Annexure-5: 11KV SWITCHGEAR SLD

CAPTIVE POWER PLANT (CPP) PACKAGE
VISAKH REFINERY MODERNIZATION PROJECT (VRMP)
JOB NO. B016

TITLE
SINGLE LINE DIAGRAM OF
11kV SWITCHGEAR

COMMENT SHEET

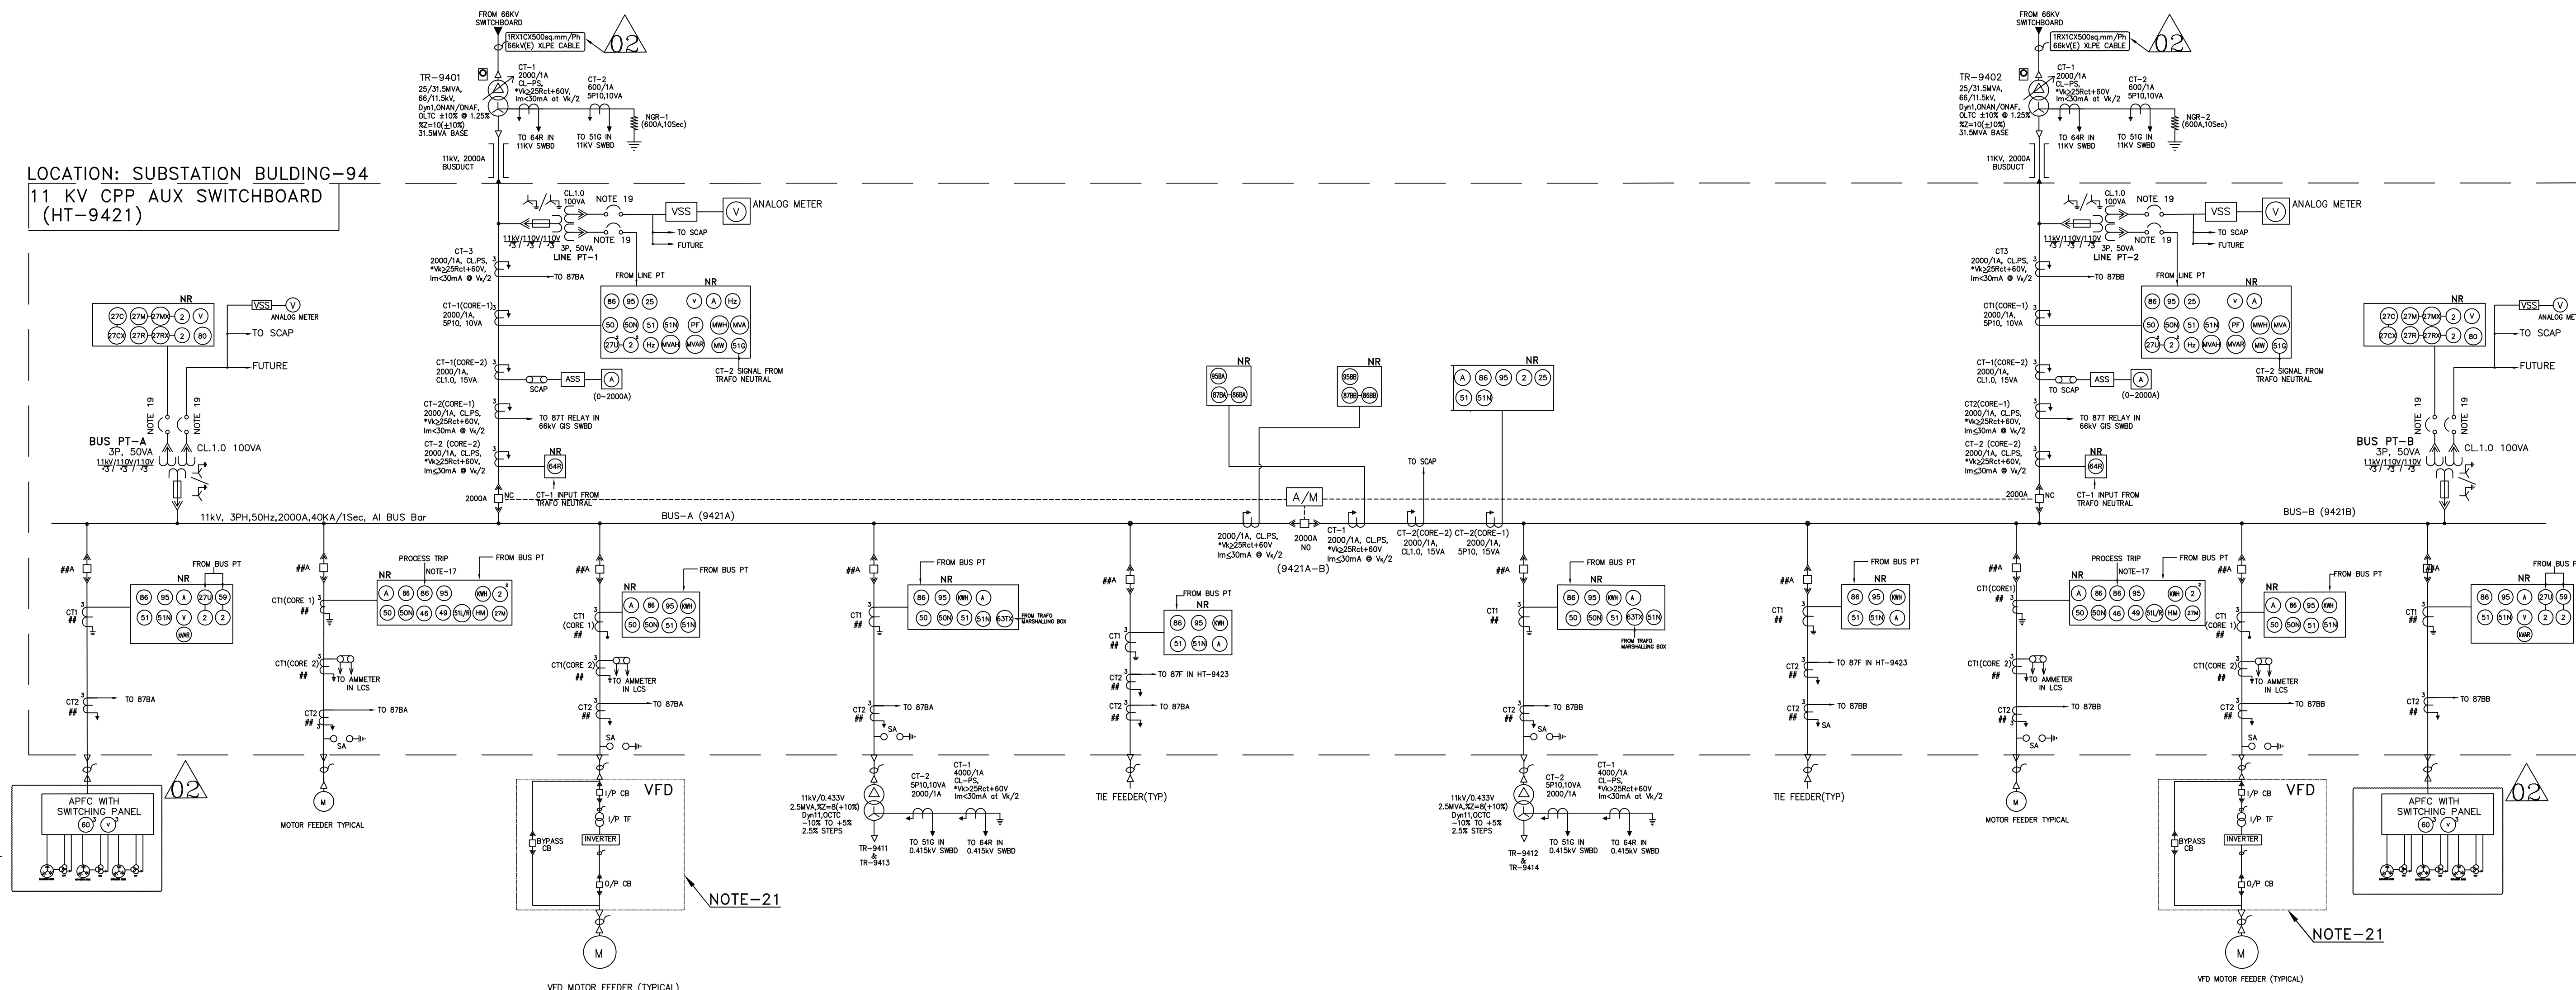
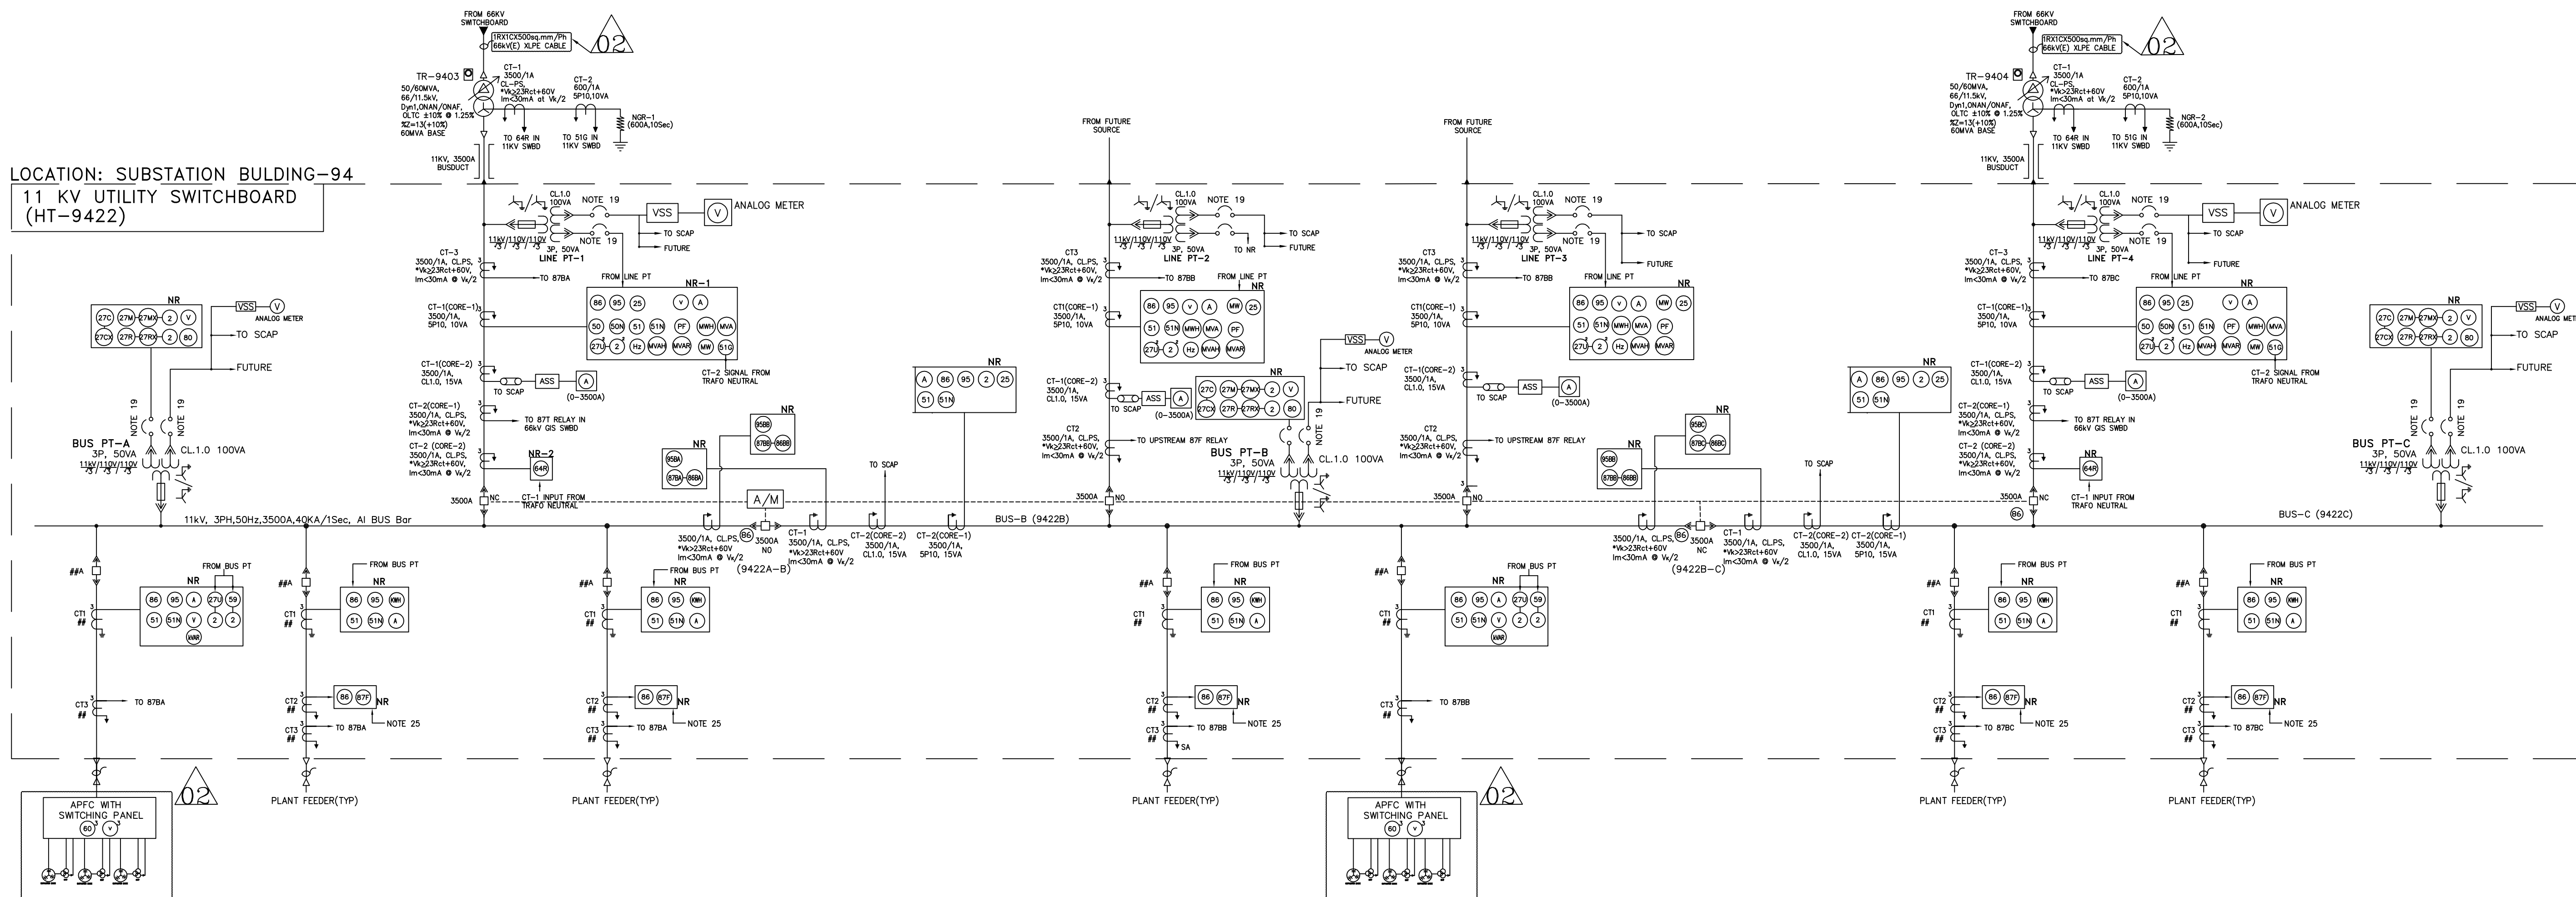
1.1	It is understood that 3 steps are provided in each capacitor bank. However the relay 60 (neutral displacement relay) is provided in 11kV switchgear. Please check.	Noted and corrected in revised SLD. Please note that, the neutral displacement relay located in the APFC panel for each step of capacitor bank

1.2	Emergency DG rating shall updated as per final sizing calculations.	Noted. The Emergency DG rating is corrected in line with revised DG set sizing calculations

1.3	66kV 1RX1CX300 sqmm is not adequate for 50/60MVA transformer. Please check and correct. Furnish 66kV cable sizing calculations.	Noted and corrected in the revised SLD. 66kV cable size is 3RX1CX500 sqmm XLPE cable with copper conductor for 50/60MVA transformer. 66kV cable sizing calculation were already furnished by BHEL-TBG for approval.
	Client comments

1.4	Insulated 110v Dc Control Bus, 240v Space Heater Bus & 110v Ac Pt Bus To Be Run Along All Switchgears For Ease Of Tapping At Respective Locations. Same to be indicated in SLD.	Noted and incorporated in revised SLD under notes
